Cherwell LPPR, Proposed Main Modifications

Site capacity sense check

Cherwell Local Plan Partial Review, Proposed Main Modifications Site capacity sense check

Figure 1: PR6a constraints, Cherwell District Council

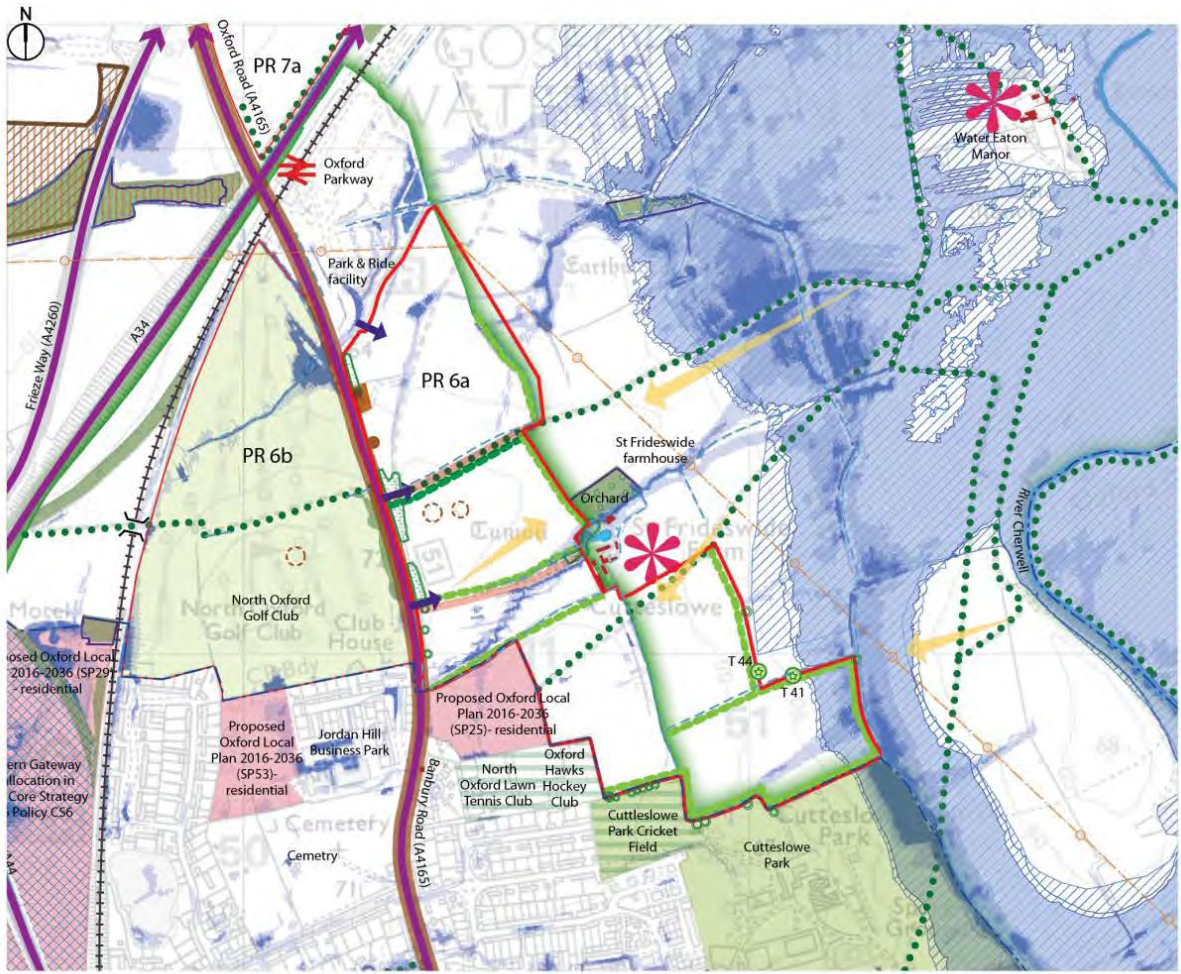
The site presents a number of east-west constraints relating to farm access routes, species-rich hedgerows and drainage corridors. It is expected that these linear features will be reflected in the eventual site layout, but are unlikely to significantly affect the site capacity at the densities proposed. They do not preclude housing development on the additional hectare of land. Key constraints are indicated on figure 1 below.

CDC has suggested that the 1 ha of land no longer required for primary school use, could be reallocated to residential use at a density consistent with the rest of the site, delivering 40 homes (690 in total). This would appear to be an appropriate response to the change in circumstances.

There are no other known significant changes in circumstance that would warrant a wider reconsideration of the 'balance' struck by CDC. A number of linear constraints across the site will reduce the efficiency of layout. Therefore a density of 39-40 dph would appear to be appropriate to both the constraints of the site and the proposed character in line with Policy PR6a place shaping principles.

Figure 2: PR6b constraints, Cherwell District Council

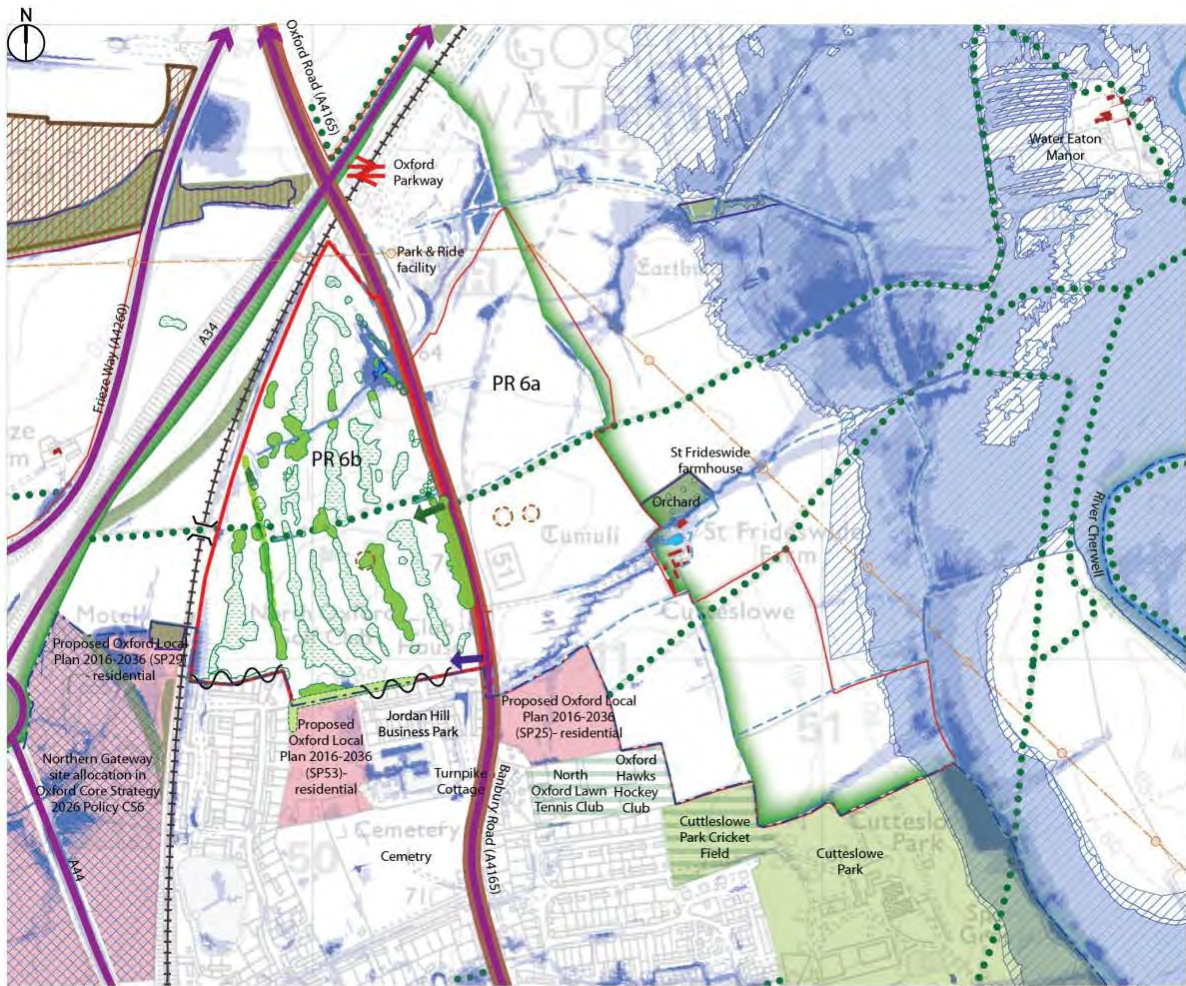
The Council's landscape and tree officers visited the site and carried out an assessment of the significance of the trees on this site which resulted in the identification of important and moderate groups of trees shown in figure 2. This identifies that the majority of the trees on the site are of moderate quality and could potentially be removed (subject to appropriate compensatory planting). However there are native and ornamental trees which should be retained and incorporated within the landscape structure. The latter have been identified as 'important groups of trees'.

Savills' submission compares the extent of net developable land assuming all trees are retained, with the extent of net developable land if only the 'important groups of trees' are retained. In the latter scenario, around 1.1 ha of additional land is developable, giving an overall net residential area of 18.5ha (58% of the total site area). (See figure 3). The constrained areas identified broadly accord with CDC's constraints plan, although it omits some smaller constraints such as TPOs and an intact species-rich hedgerow.

The latter point highlights that in addition to the release of 1.1 hectares of developable land, the overall layout efficiency and therefore site density could reasonably be expected to increase, resulting in a further increase in the site capacity. To that end, Savills proposes a net density of 40dph across 18.5ha, which would generate 740 dwellings.

The delivery of 600 homes would involve an increase in the net residential density from 24 to 27 dph. This remains a relatively low density, enabling delivery of the character envisaged under place shaping principle 25.

However, considering the site's integration with adjacent sites and having regard to the additional information now available, CDC may wish to consider a further increase in density to approximately 30 dph, resulting in 672 homes. Taking the 18.5 ha 'net, net' developable area indicated by Savills, the density would be 36 dph.

We understand that following receipt of draft consultant advice on a range of topics, CDC is proposing an updated housing allocation for PR6b of 670 homes, at a net density of 30 dph. This is in line with the findings of the capacity sense check.

Figure 4 Map showing CDC's initial suggestion for a modified boundary and the Pegasus / Hill proposed boundary

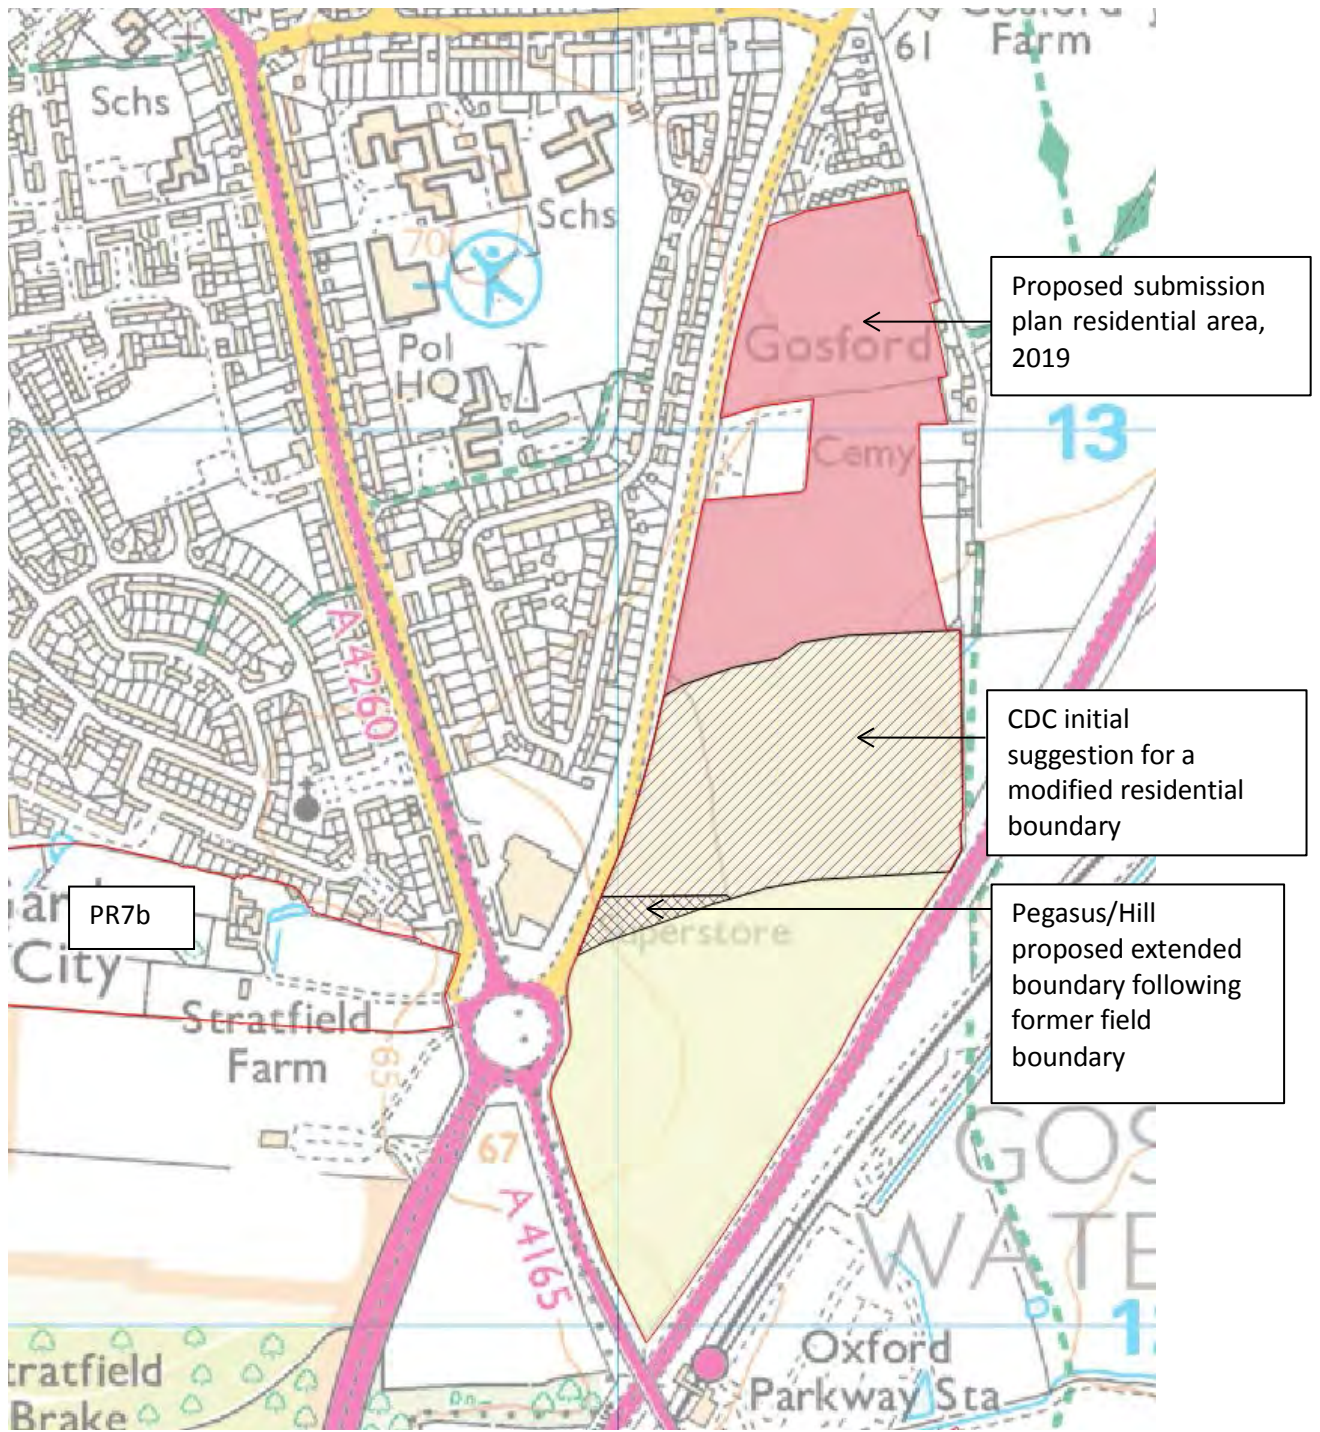
The gross residential area which is promoted, as shown on figure 4, is approximately 20.55 ha (our measurement). The net residential area noted on their concept masterplan (figure 5) is approximately 11.4 ha and they propose approximately 430 dwellings at a density of 37.5 dph.

A working proposal was suggested by CDC for testing. CDC suggested an increase in the gross residential area to 20 ha (20.08 ha our measurement based on Figure 4) by incorporating the additional field to the south bordered by the existing hedgerow and land adjacent to Bicester Road (an additional 9ha of land). The proposed boundary in the western part does not extend as far south as the boundary promoted by Pegasus/Hill. The difference is approximately 0.47 ha (our measurement).

In either boundary scenario, the western parcel of land is triangular, which will lead to some inefficiency in the layout. CDC's proposed boundary meets Bicester Road at nearly 90 degrees, while the site promoter's boundary is angled and this may lead to further inefficiency in the site layout.

In conclusion, the increase in numbers appears to be appropriate. Either southern boundary could result in an acceptable design, subject to detailed masterplanning. The southern boundary should therefore be determined by other considerations such as the appropriate Green Belt boundary.

We understand that following receipt of draft consultant advice on a range of topics, CDC is proposing to revise the boundary to reflect the former field boundary. This increases the site area to approximately 21 ha resulting in a reduction in net density to 29 dph. This is in line with the findings of the capacity sense check.

Figure 7: Marked-up extract from Manor Oak Homes (RG+P) PR7b Presentation Site Layout, 29.08.19. Area in blue shows housing within the Council’s proposed modified residential development area (Alan Baxter).

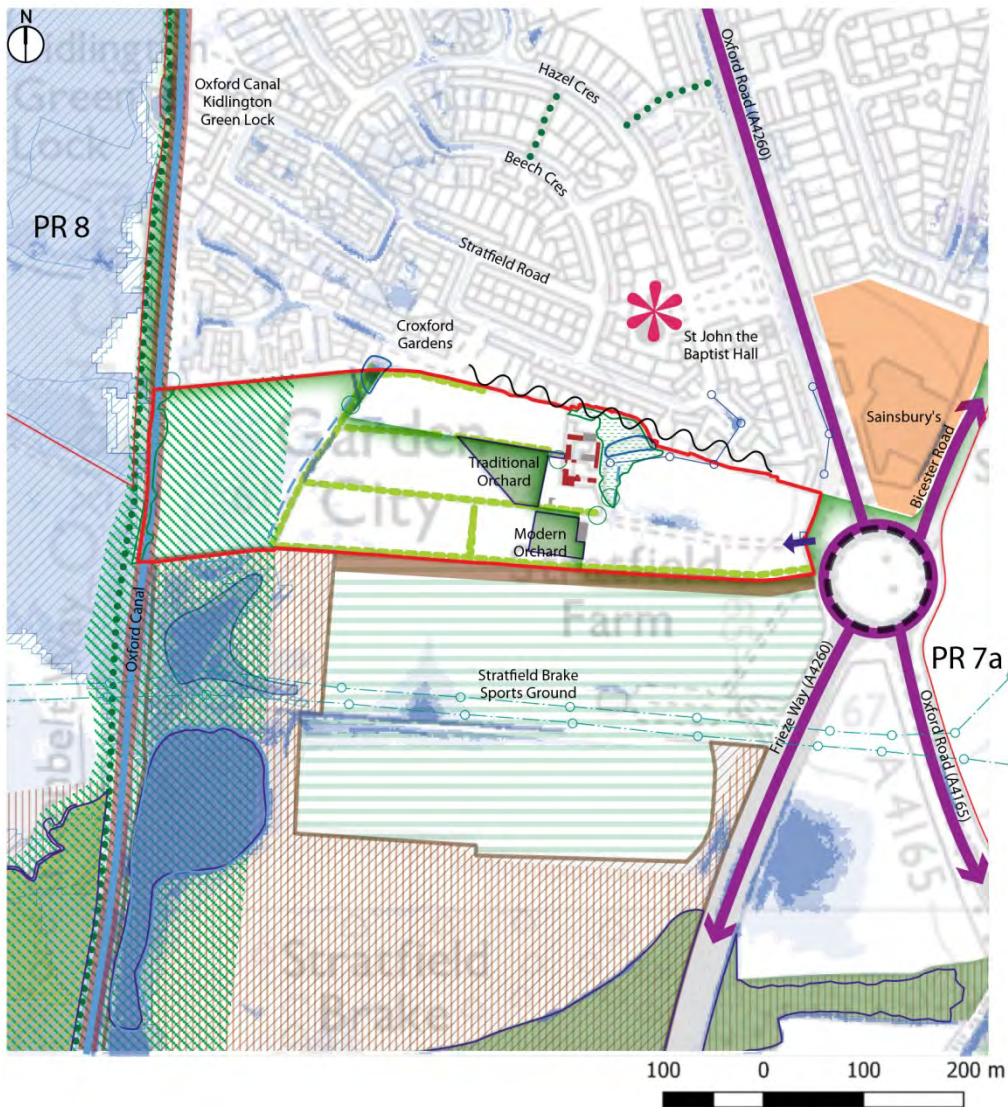
The development area shown by the promoter's site layout is greater than the extension which CDC is currently testing and takes development to the southern boundary with Stratfield Brake, on the western part of the site. Two east-west vehicle accesses are proposed, to the north of the farmhouse and on the southern boundary. The layout assumes the existing curtilage listed farm outbuildings will be demolished and the existing track serving the farmhouse will be realigned in response to OCC's potential site access location. This may not be acceptable on Conservation grounds. One of the two hedgerows crossing the western part of the site has been removed.

Counting only those houses which fall within CDC's proposed modified development boundary, and excluding 3 homes which are located on the site of the existing outbuildings, a total of 119 units appear to be shown.

To test the capacity assumptions, we have prepared a high level sketch plan based on standard block depths for 3-4 bed houses of a range of typologies and 3 storey apartments (see figure 8). Although it takes a different design approach, it broadly supports the conclusions of the Manor Oak Homes capacity testing.

Capacity testing supports the increase in housing numbers within the site to around 130 units. However, given the constraints of the site it reveals that to achieve this density of development it is likely that some apartment units will be required. Located at the entrance to the site, 3 storey blocks could in our view be an appropriate scale to mark the entrance to Kidlington (subject to their detailed design).

We understand that following receipt of draft consultant advice on a range of topics, CDC is proposing an updated housing allocation for PR7b of 120 dwellings, at a net density of 34 dph. This slight reduction allows greater flexibility to accommodate known site constraints fully, and create a layout which is appropriate to the historic farmhouse and its setting.

Figure 10: Mark-up based on Site Framework Plan, by Define on behalf of Merton College, showing land take for site promoter's three extended site options and OCC required play field land take.

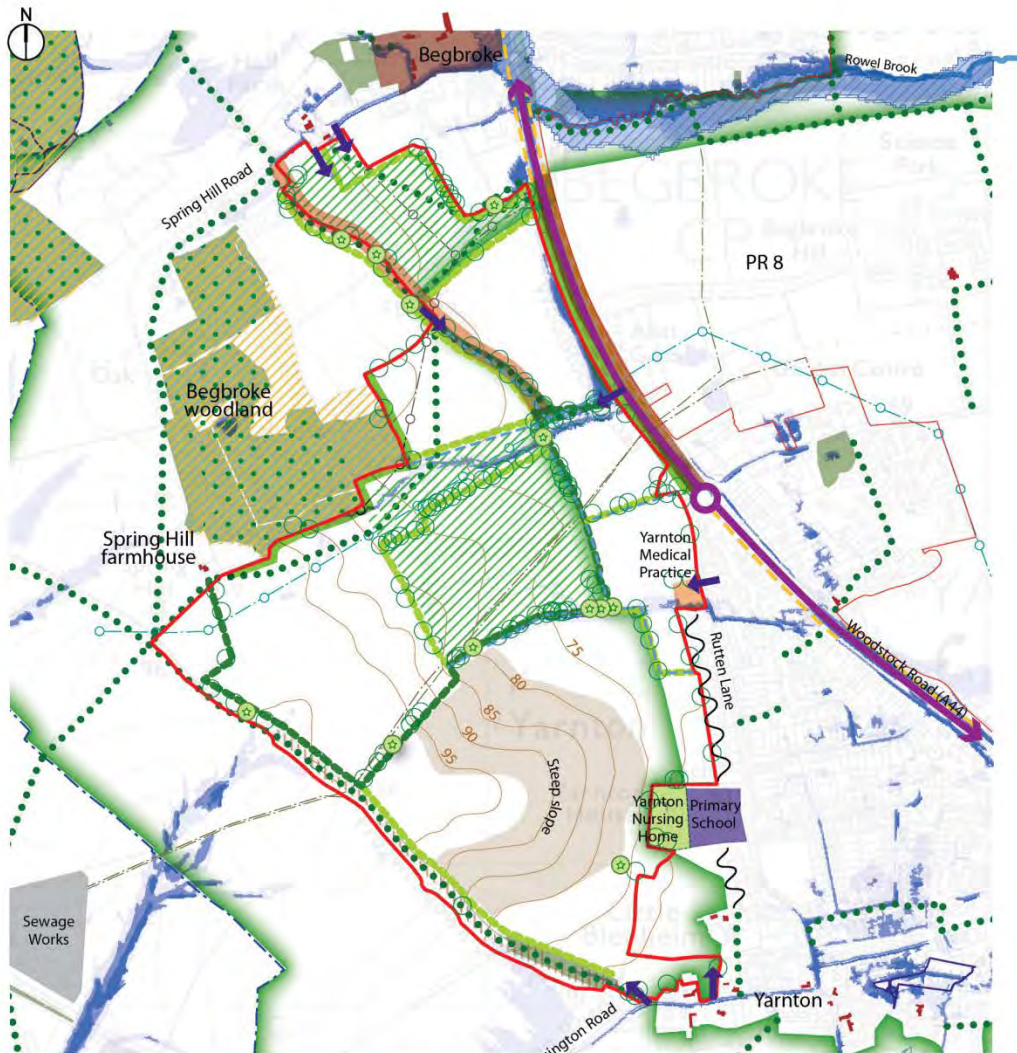
A series of capacity testing options have been prepared by the site promoter, which consider revised development boundaries incorporating land to the west. See figure 10. Three options are presented:

The site promoter, working broadly to the same gross residential area, identifies a smaller residential area of 15.3 ha. This highlights the potentially significant land take associated with constraints including hedgelines and buffers, and drainage attenuation on the site.

The extended portion of the site will be separated from the parcels of land to the east by an established hedge line which is to be retained. The site promoter's layout suggests the western parcels will be served by additional SuDS infrastructure and access roads. As a result there is a limited cumulative benefit to the site layout efficiency as a result of extending the site to the west.

A reduction in density and increase in developable area would therefore appear to be an appropriate response to both constraints and character considerations. However, given the

potentially significant land take associated with the site's constraints CDC may wish to consider a further reduction in density to around 30 dph.

We understand that following receipt of draft consultant advice on a range of topics, CDC is proposing a refinement to the residential development boundary for PR9 giving a gross residential area of 25 ha and a net area of 17.5ha. An updated housing allocation of 540 dwellings, at a density of 31 dph is proposed. This slight reduction in density allows greater flexibility to accommodate known site constraints fully.
